Model Nakamichi 600 (2 Head Cassette Console)

No. NR-0009 (1/3)

Date 20 July, 1977

Subject Modification of Reel Hub Ass'y

Fig. 1.1

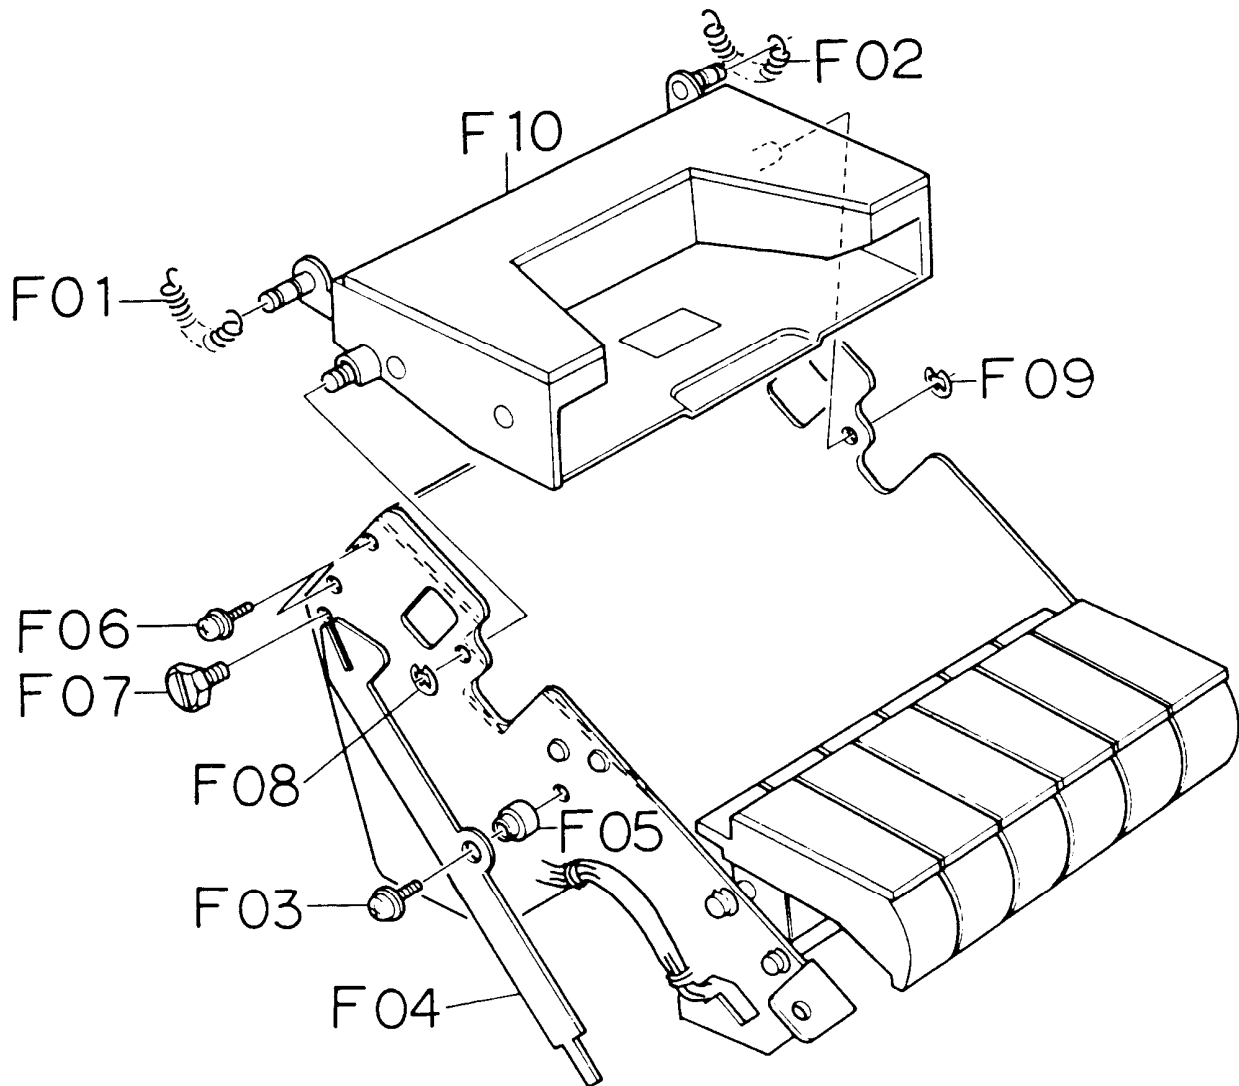
1. Disassemble the Cabinet by removing five screws.
2. Disassemble the Front Panel by removing four screws and VR knobs.
3. Disassemble the Mechanism Ass'y by removing three screws and two connectors.
4. Remove the Cassette Case Ass'y and Cassette Lid Ass'y.
Referring to Fig. 1.1, remove F01 through F10 (Cassette Case Ass'y).
Referring to Fig. 1.2, remove F01 and F02 (both sides of Lid Springs) with pincers carefully.

Fig. 2

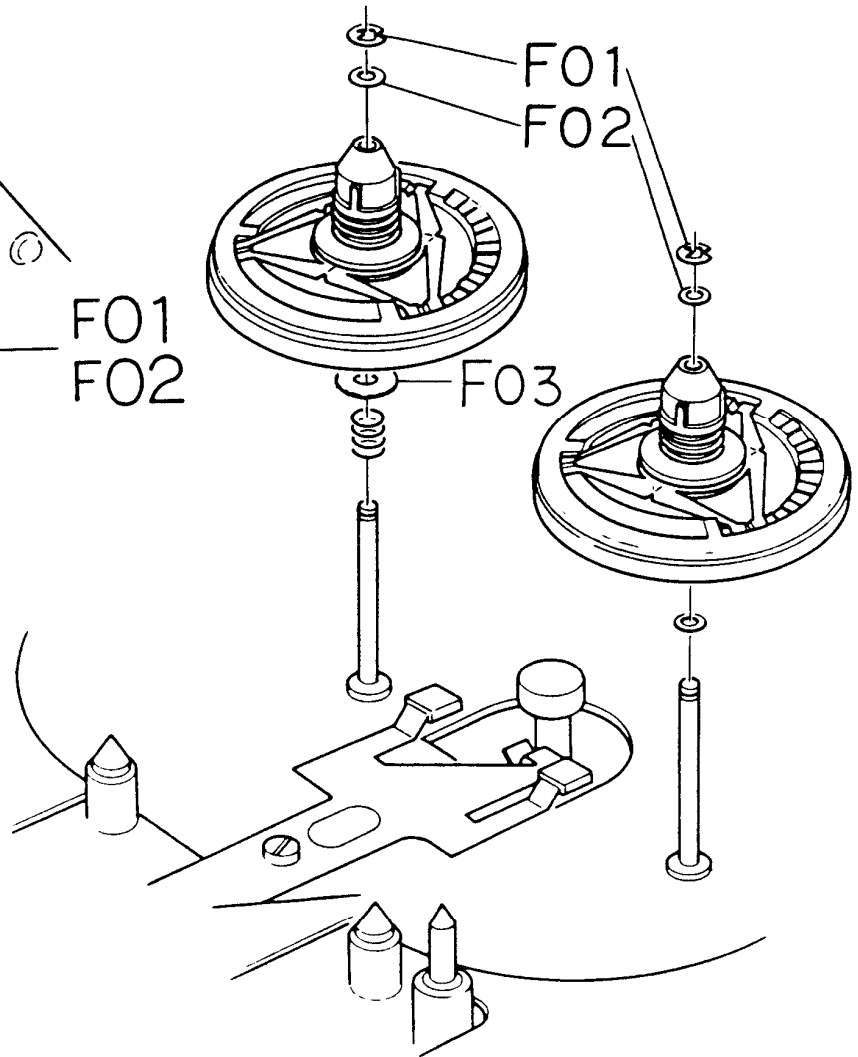
The newly improved reel hub ass'y eliminates above trouble by adding the spring mechanism in the reel hub ass'y so as to sink the sprocket of reel hub ass'y when a cassette tape is loaded. Thus, complete loading of a cassette tape into the cassette case is possible.

Previous Parts:

CA03268A Reel Hub T (B) Ass'y -- 1 pce.
CA03269A Reel Hub S (B) Ass'y -- 1 pce.

New Parts:

CA03300A Reel Hub C Ass'y -- 2 pcs.
OC03994A Supply Mylar Washer -- 1 pce.

5. Dismount both reel hubs of supply side and take-up side by removing the E-ring from the top of the reel hubs. Refer to Fig. 2. Then replace them with new reel hub assemblies.
6. Mount the Cassette Case Ass'y and Cassette Lid Ass'y.
7. Mount the Mechanism Ass'y and Connectors.
8. Load the Torque Gauge and check whether the take-up and rewind torques are in a range of 45 ± 10 g-cm and 35 to 60g-cm, respectively. If either torque is out of the range, adjust the torque by moving Reel Hub Spring, as shown in Fig. 3.
9. Measure the tape speed and wow/flutter and check whether the measured values are in their specified ranges. If these values are out of the ranges, re-adjustment or replacement of defective parts (including drive belt in wow/flutter measurement) will be required.
10. Mount the Front Panel and Cabinet.
